UNITED STATES PATENT AND TRADEMARK OFFICE

APPLICATION NO.	FILING DATE	FIRST NAMED INVENTOR	ATTORNEY DOCKET NO.	CONFIRMATION NO.
10/816,075	03/30/2004	Yeong Mou Su	4358DL	8894

Office Action Summary

DETAILED ACTION

WO 87/00108

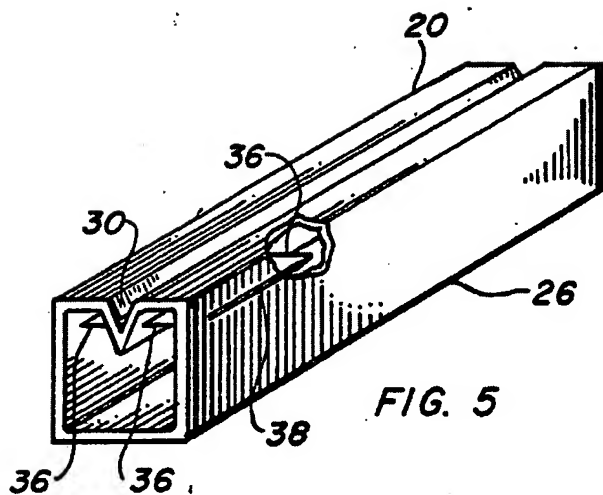
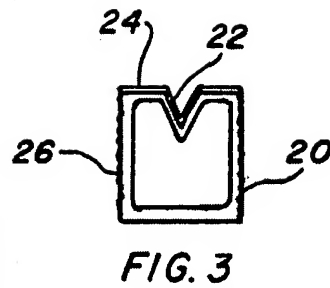
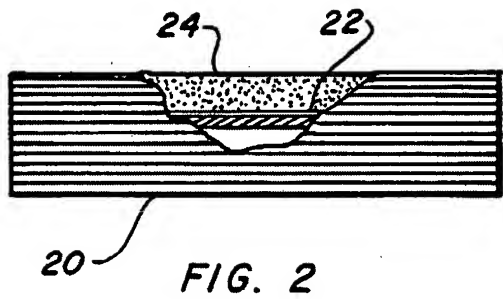
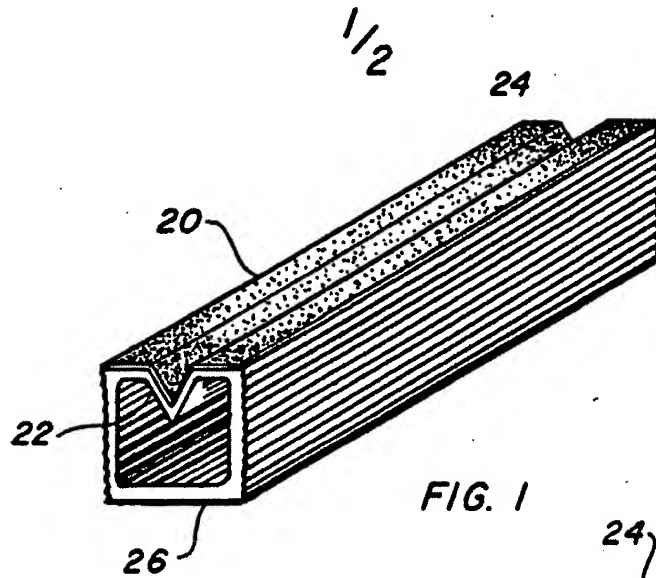
2. Claims 1, 2, 3, are rejected under 35 U.S.C. 102(b) as being anticipated by WO/87/00108.

With reference to Figures 1-5, WO/87/00108 discloses the claimed invention including:

a) sharpener device comprising a block 20; b) a V-groove 22 having abrasive coated surface 24 therein; and c) a passage 36 formed in said abrasive coated surface of said block.

5,123,764

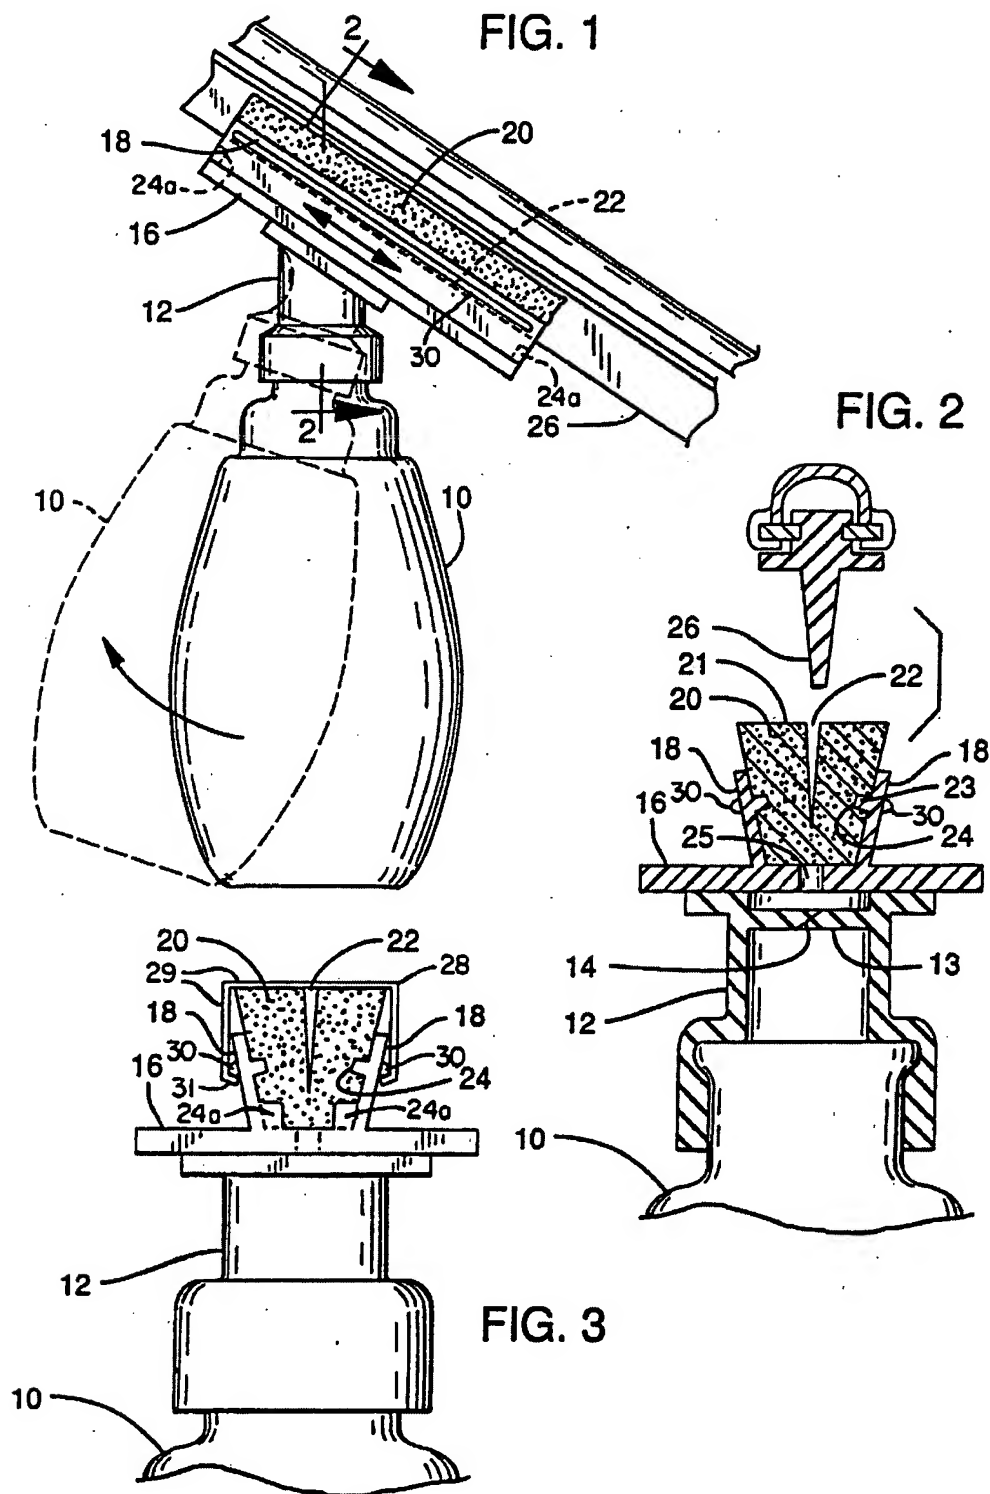
With reference to Figure 2, Duncan discloses a utility cleaning tool for windshield wiper blades comprising an orifice 14 formed in block 12 and in communicating with groove 22 to deliver cleaning fluid from chamber 13 to the cleaning surface 20. Furthermore, Duncan teaches a cover 29 to seal groove 22 when the cleaning tool is not in use to protect the cleaning element 20.

Thus, it would have been obvious to one having ordinary skill in the art at the time the invention was made to have modified the WO'108 sharpener with fluid deliver means as taught by Duncan'764 in order to allow clearing fluid to be delivered to the abrading surface during the abrading process to remove the debris created by the abrading process.
